**Entrance Corridor Review Board
Certificate of Appropriateness Request for Redevelopment of 1185 Seminole Trail**

**Planning Commission Regular Meeting
Date of Planning Commission Meeting: July 8, 2025**

Project Name: Residential Seminole Trail
Property Street Address: 1175-1185 Seminole Trail (formally 1185)
Property Owner: Brownwood Properties, LLC, et al
Project Planner: Dannan O'Connell
Zoning: Highway Corridor with Entrance Corridor Overlay (prior zoning applies.)
Entrance Corridor Overlay District: Corridor 1, Route 29 North (from corporate limits to Ivy Road),
Sub-Area A (corporate limits to 250 Bypass)
FLUM designation: Urban Mixed-Use Node
Tax Map/Parcel #: 41C001000
Site Acreage: 4.04 acres.
ERB staff report prepared by: Jeff Werner, AICP, Preservation and Design Planner
Submittal: [Attached] Hord-Coplan-Mach drawings *Residential Seminole Trail ERB Exhibit*, dated May 2025, 24 sheets. (Application submitted by Collins Engineering.)

LANDSCAPE PLAN

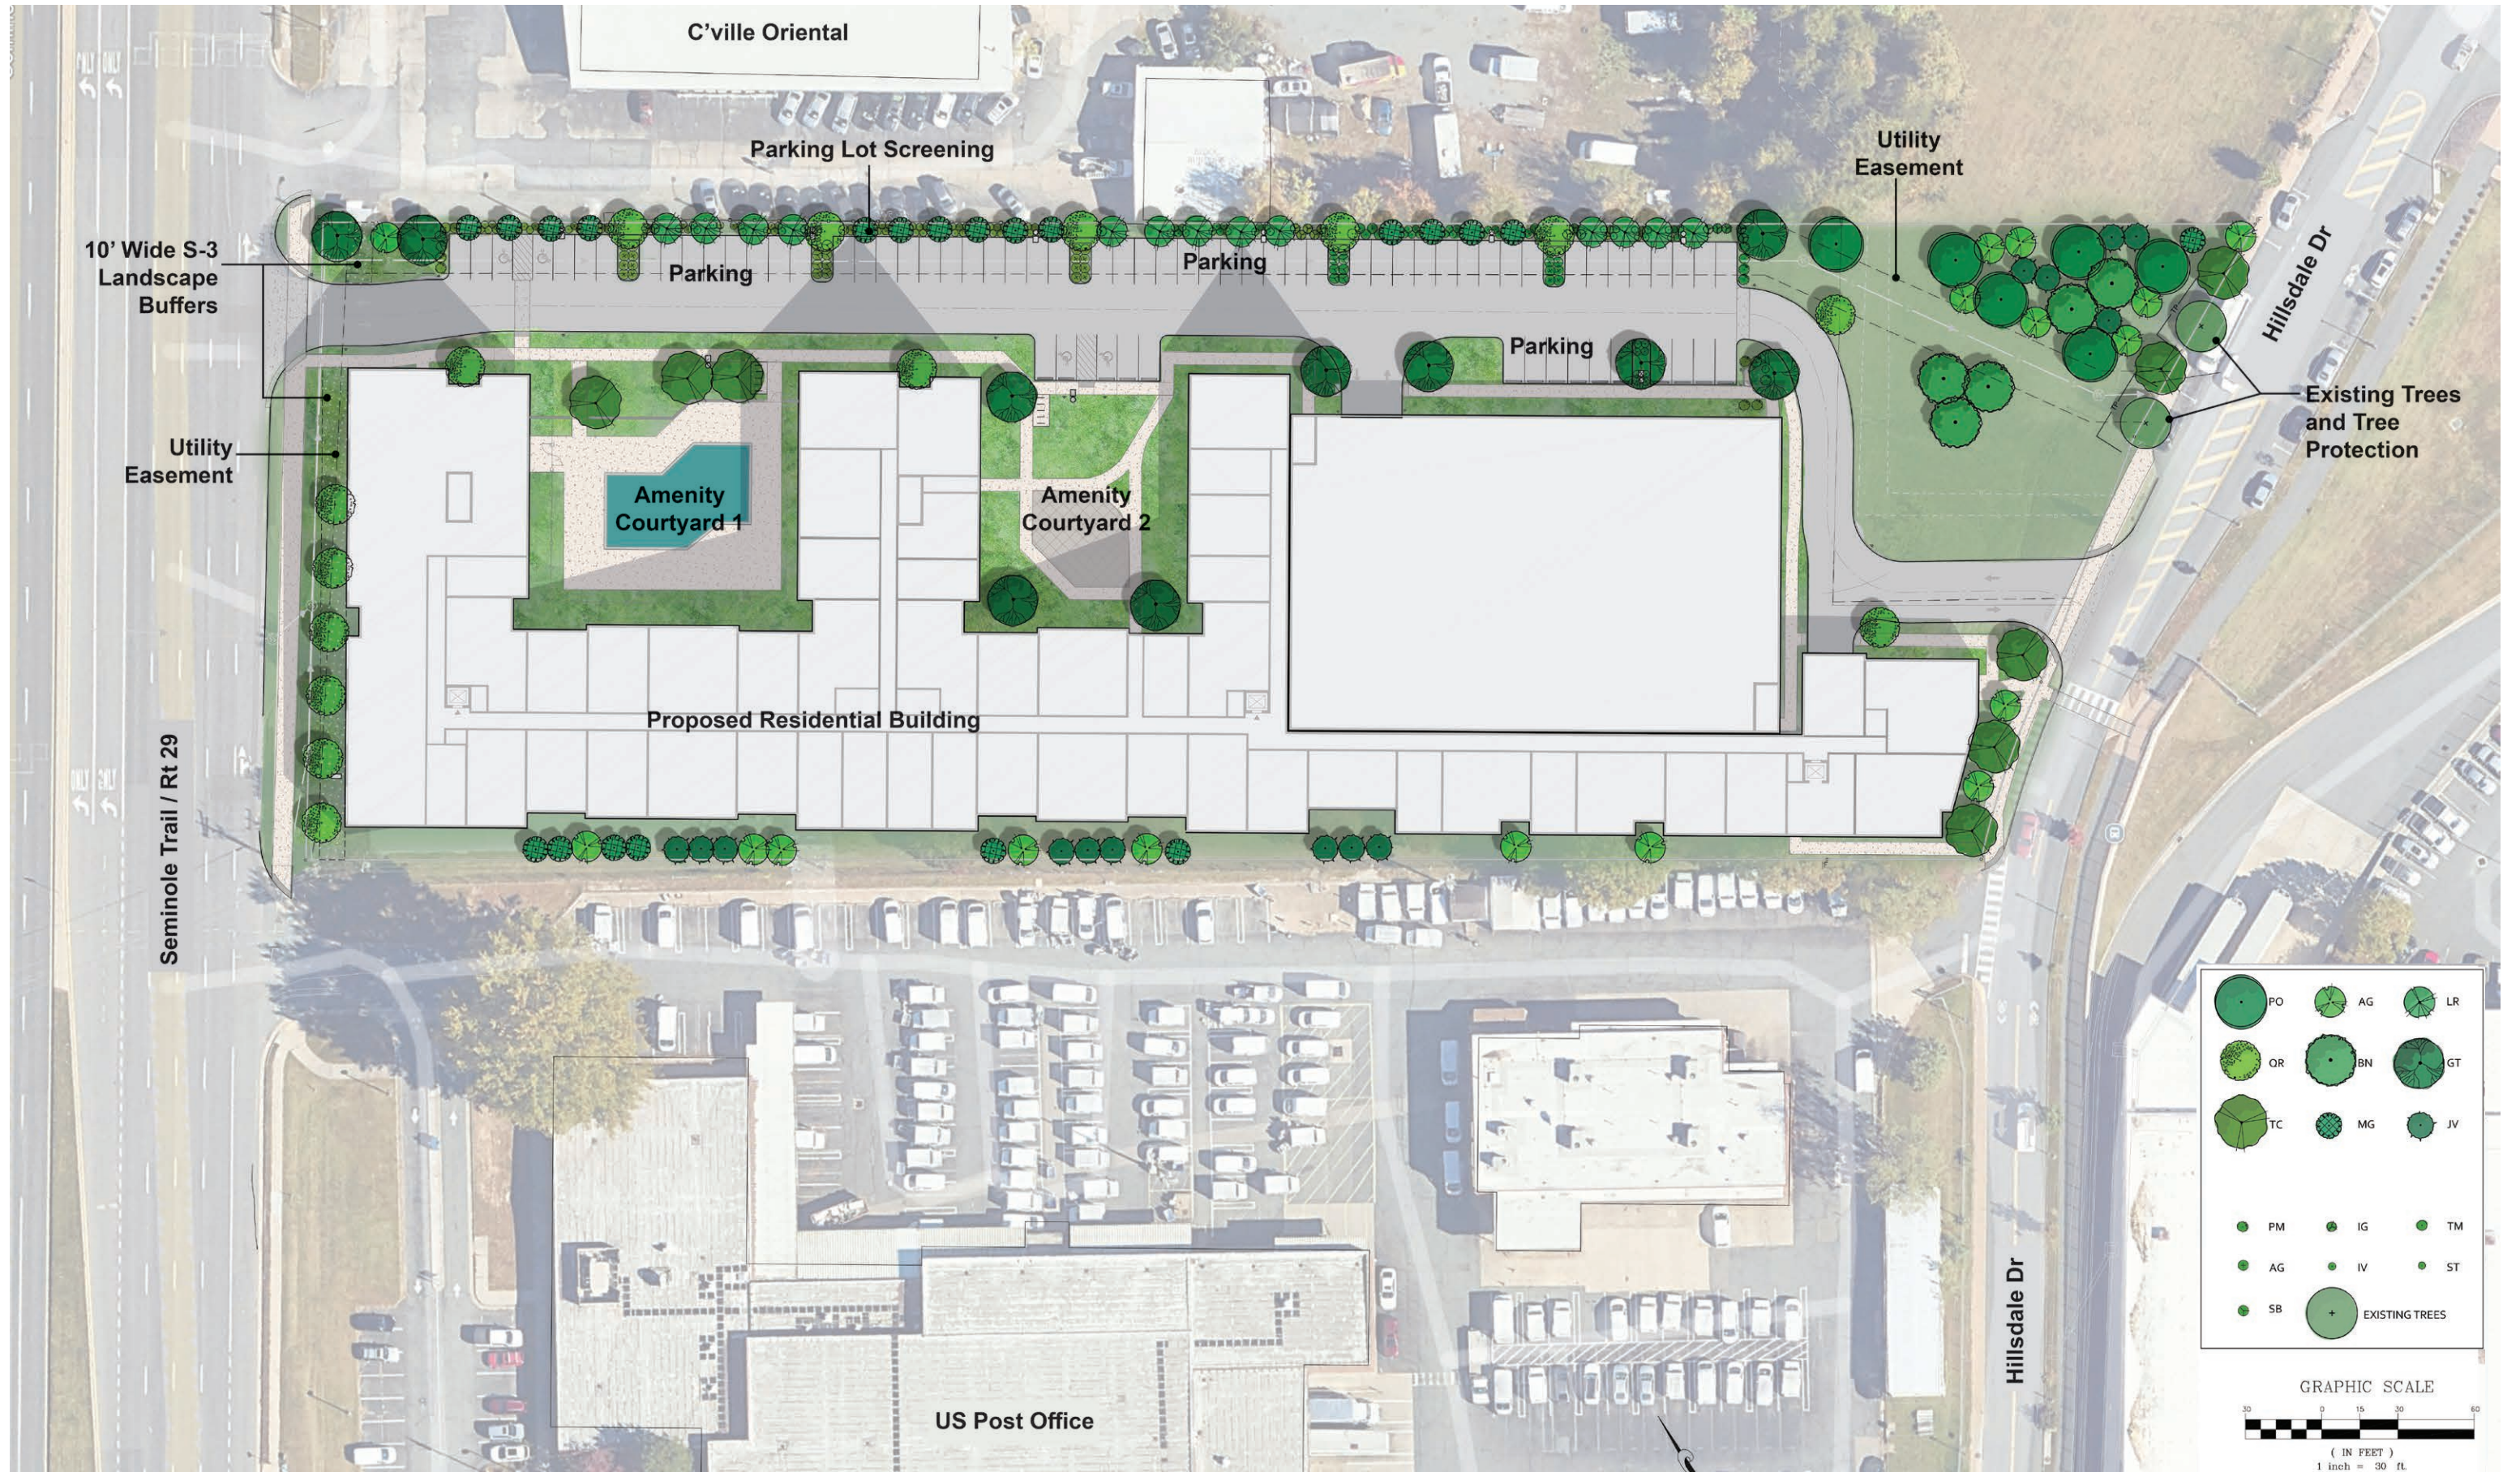
2. Include appropriately scaled trees, shrubs and other plantings to provide beauty as well as shade, within a pedestrian gathering place, and as screening for parking, utilities, and service areas.	(See landscape plan)	n/c

8. Expand use of seasonal color in plantings.	A variety of species is proposed.	Plantings include seven deciduous tree species, two evergreen tree species, and seven varieties of shrubs

d. Using shade trees of sufficient number and size at maturity to shade a substantial portion of the lot. Consider orientations that would provide the greatest shade during summer months. Smaller, more decorative trees can be used closest to buildings.	A significant number of trees are proposed.	See above re: landscaping plan

LIGHTING PLAN

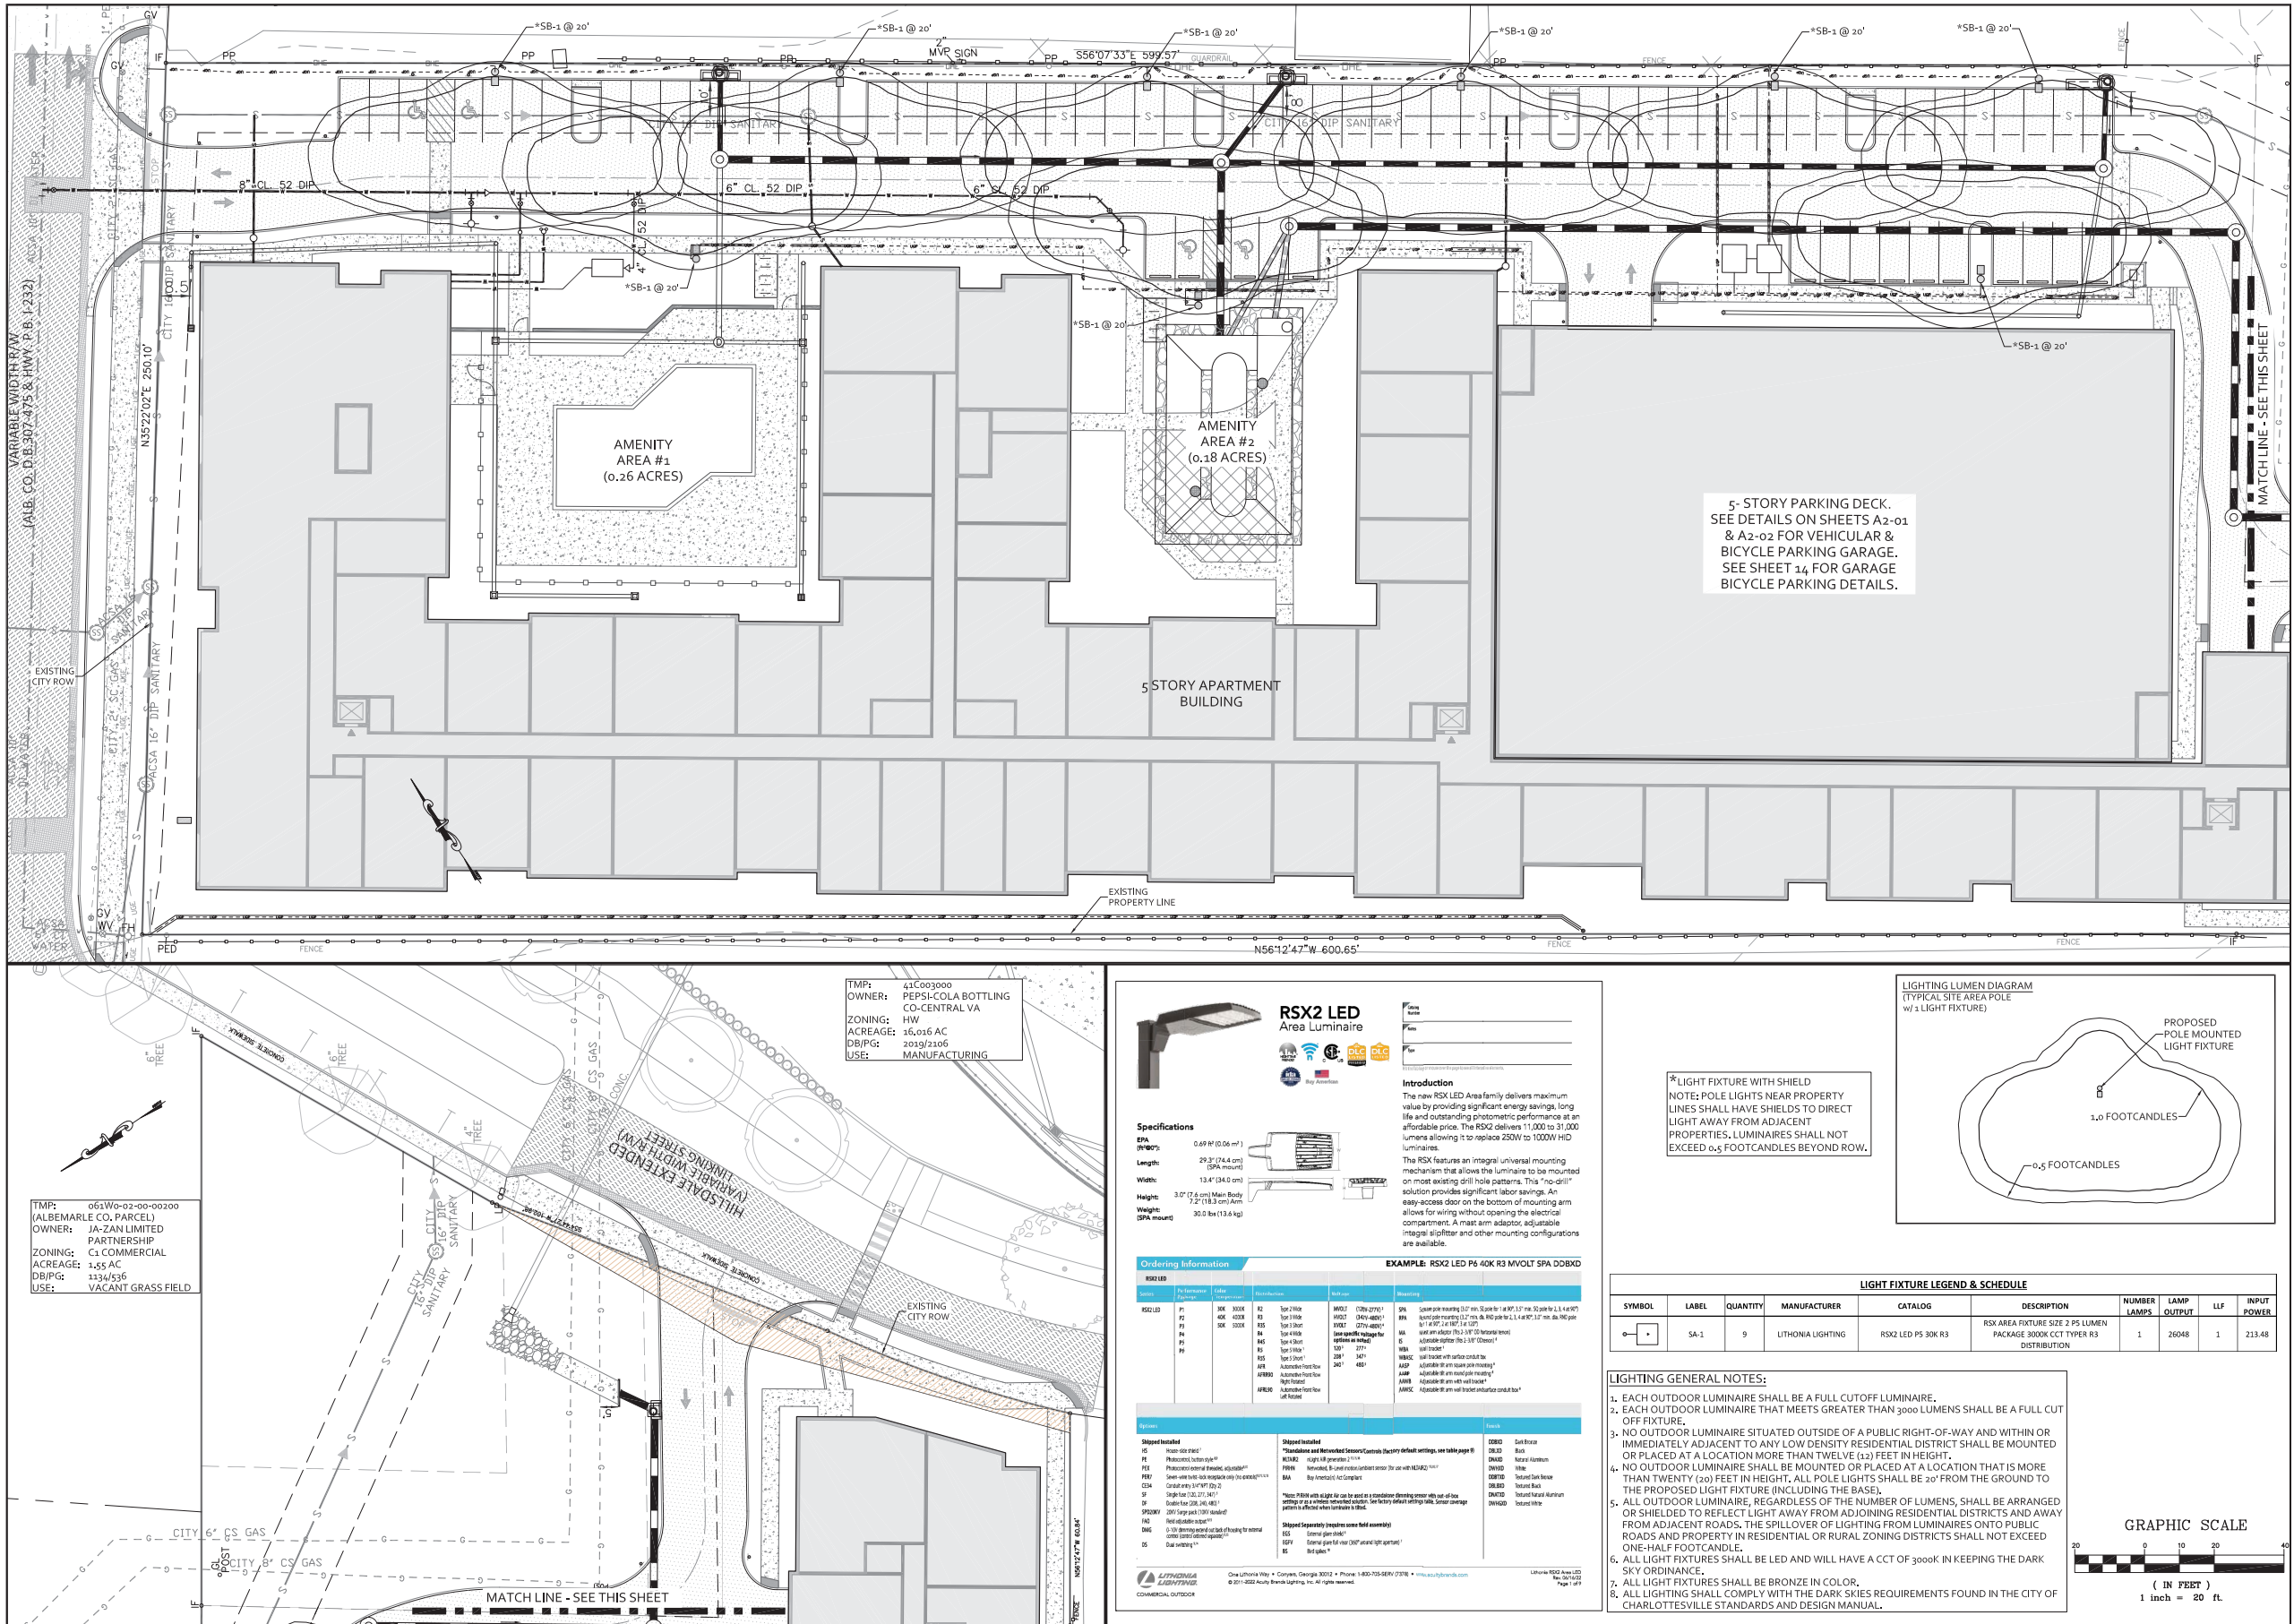
Chapter III: Guidelines for Sites, G. Lighting	Applicant's Comment	Staff Comment
1. Use full cutoff luminaires in accordance with City lighting requirements to provide better lighting and prevent unwanted glare. Lighting should at all times be designed to prevent light pollution in the form of light transmission laterally beyond site boundaries or upward to the sky.	Full cutoff luminaires are proposed.	Concur

3. Lighting should provide for appropriate and desirable nighttime illumination for all uses on and related to the site to promote a safe environment.	A photometric plan has been prepared to ensure appropriate light levels.	Concur
